ADDENDUM NO. 5
TO
REQUEST FOR PROPOSALS
FOR
HAWAII CONVENTION CENTER
SLATE TILE REPLACEMENT PROJECT
RFP NO. 2023-4

DATED: September 26, 2023

**REQUEST FOR PROPOSALS
SLATE TILE REPLACEMENT
FOR HAWAI'I CONVENTION CENTER**

STONE TILE ON CONCRETE

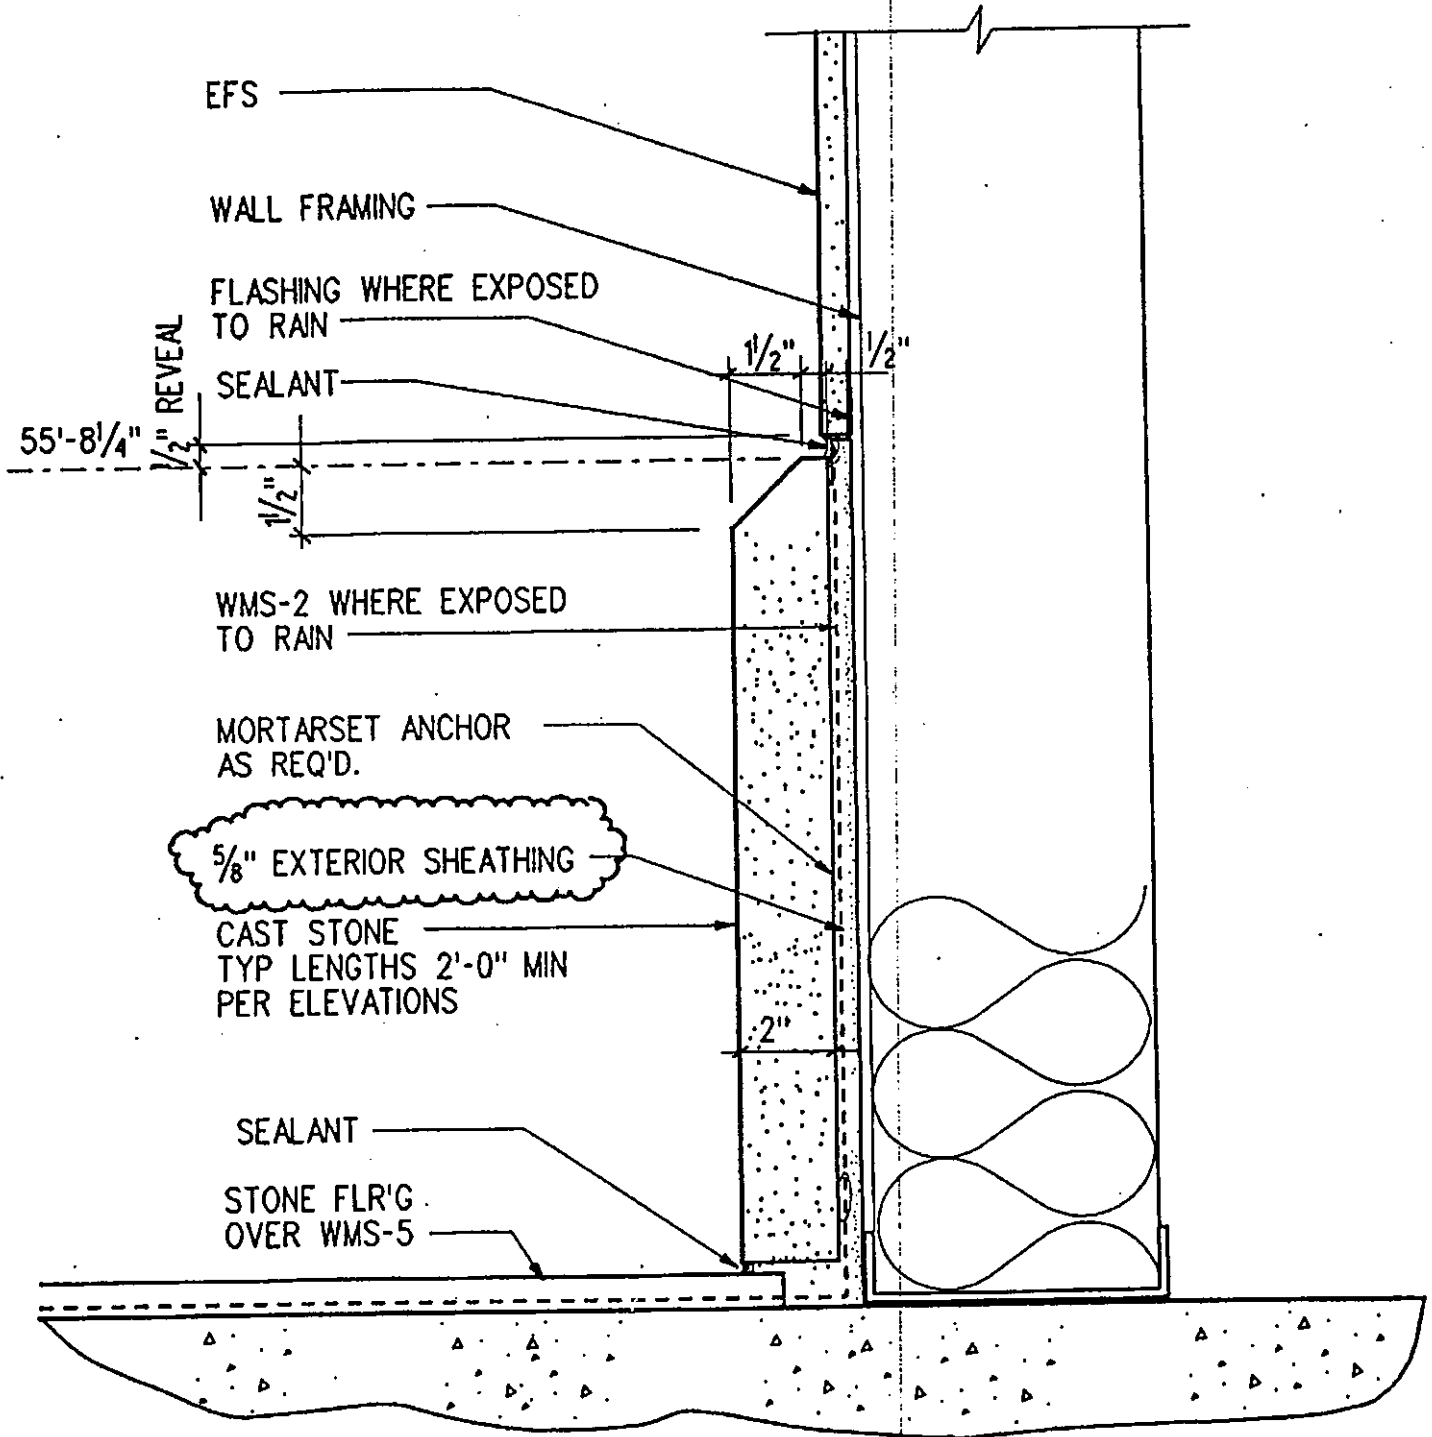
ITEM NO.	QUESTION / RESPONSE
Q-17	Reference Appendix C, Section 3.5 Unit Prices. Draft Contract Form includes a unit price for Request to Stop Work. Will this be determined at time of award? <i>No. The intent is to understand what the daily charge will be from the Contractor if there is a sudden Stop Work Order.</i>
Q-18	HCC Comment To Proposer: Current tile thickness is 3/8" - 1". Will this create a problem for installation?
Q-19	Please provide specifications and details of existing stone base. <i>Unfortunately, there are no specifications for this base.</i>
Q-20	If a match to the existing stone base cannot be found, will HCC consider a different base? <i>Yes. Contractor to recommend closest base possible. Selective Stone able to assist in stone match.</i>
Q-21	Please provide specifications and details of existing stone base installation method. This will help understand how to demolish the stone without affected the existing wall. <i>The intent is to remove and salvage as much base as possible. HCC has removed some and willing to show Contractor. See attached drawings for reference.</i>

Q-22	Please provide specifications and details of existing wall behind the stone base. <i>See attached drawings for reference.</i>
